Informal document GRB-55-02
(55th GRB, 7-9 February 2012,
agenda item 7(b))

Proposal for amendments to Regulation No. 9
(Uniform provisions concerning the approval of category L₂, L₄ and L₅ vehicles with regard to noise)

Statement of Technical Rationale and Justification

Figure 1
Positions for testing the vehicle in motion

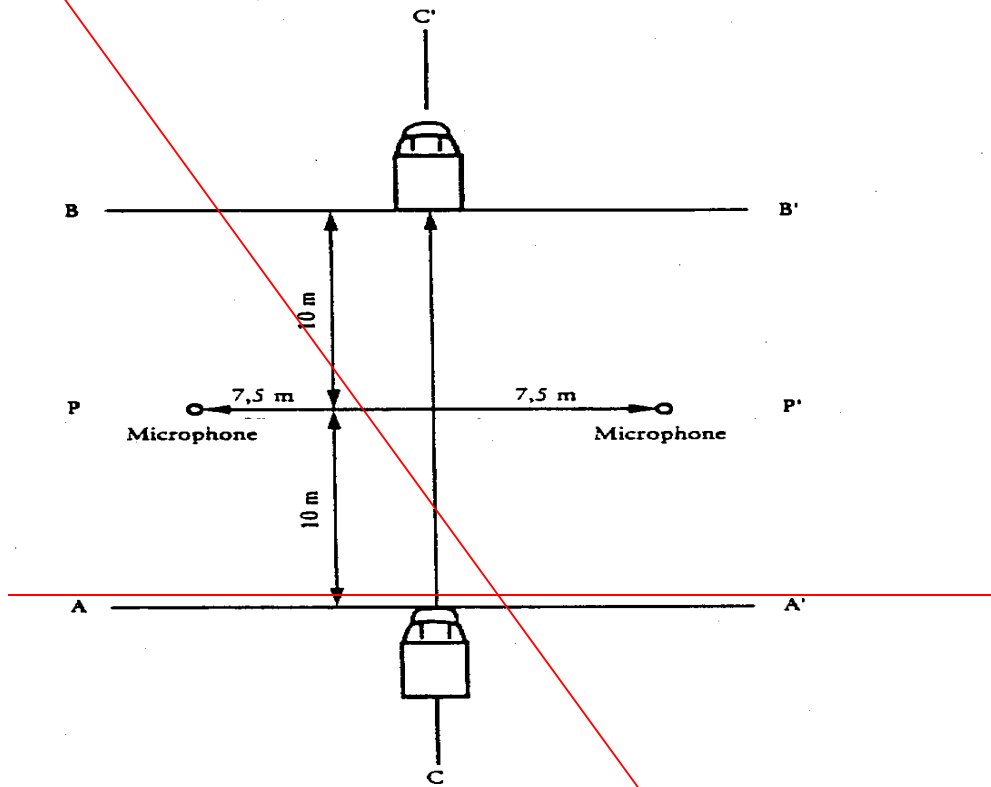
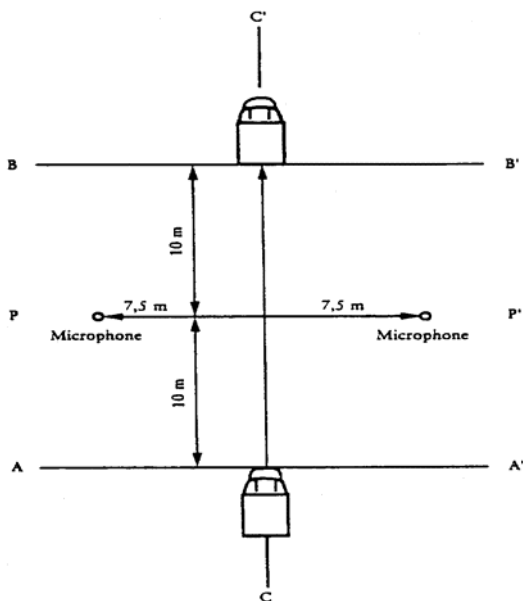
3.1.1.2. ~~The microphone shall be situated 1.2 m ± 0.1 m above ground level at a distance of 7.5 m ± 0.2 m from the path of the vehicle's centre line, measured along the perpendicular (PP') to that line (Fig. 1).~~

The distance of the microphone positions from the line CC', on the microphone line PP', perpendicular to the reference line CC' on the test track (Figure 1), shall be 7.5 ± 0.05 m.

The microphones shall be located 1.2 ± 0.02 m above the ground level. The reference direction for free-field conditions (see IEC 61672-1:2002) shall be horizontal and directed perpendicularly towards the path of the vehicle line CC'.

Figure 2
Positions for testing the stationary vehicle

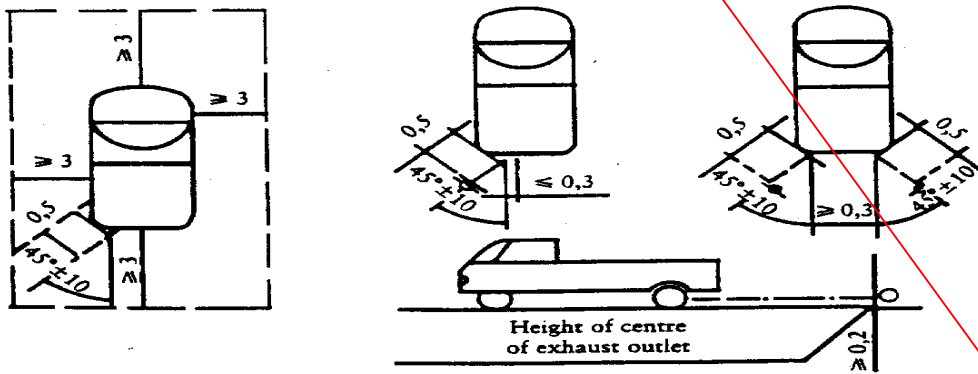
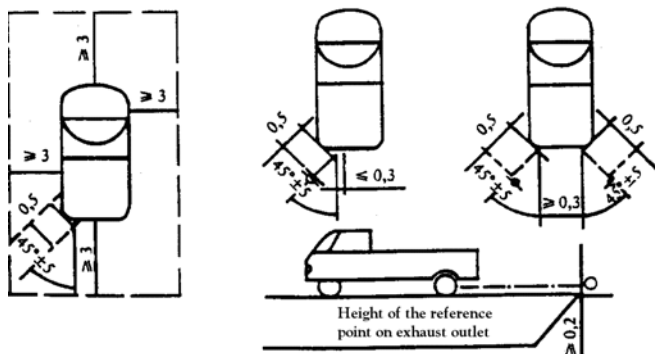
3.2.4.2. ~~Position of the microphone~~ **Positioning of the microphone (see Figure 2)**

~~The height of the microphone above the track surface shall be the same as that of the exhaust outlet, but in any case shall not be less than 0.2 m. The microphone diaphragm shall be directed towards the exhaust outlet and placed at a distance of 0.5 m from it. The maximum sensitivity axis of the microphone shall be parallel to the track surface and form an angle of $45^\circ \pm 10^\circ$ with the vertical plane of the direction of the exhaust outlet.~~

The microphone shall be located at a distance of 0.5 ± 0.01 m from the reference point of the exhaust pipe defined in Figure 4 and at an angle of $45 \pm 5^\circ$ to the vertical plane containing the flow axis of the pipe termination. The microphone shall be at the height of the reference point, but not less than 0.2 m from the ground surface. The reference axis of the microphone shall lie in a plane parallel to the ground surface and shall be directed towards the reference point on the exhaust outlet.

Figure 4. Reference point

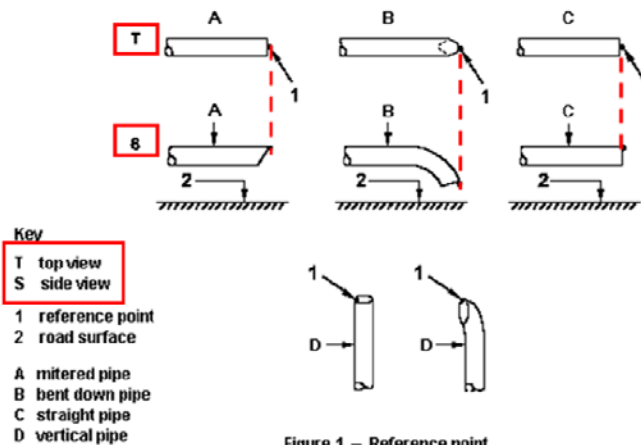
The reference point shall be the highest point satisfying the following conditions:

- (a) The reference point shall be at the end of the exhaust pipe,**
- (b) The reference point shall be on the vertical plane containing the exhaust outlet centre and the flow axis of the exhaust pipe termination.**
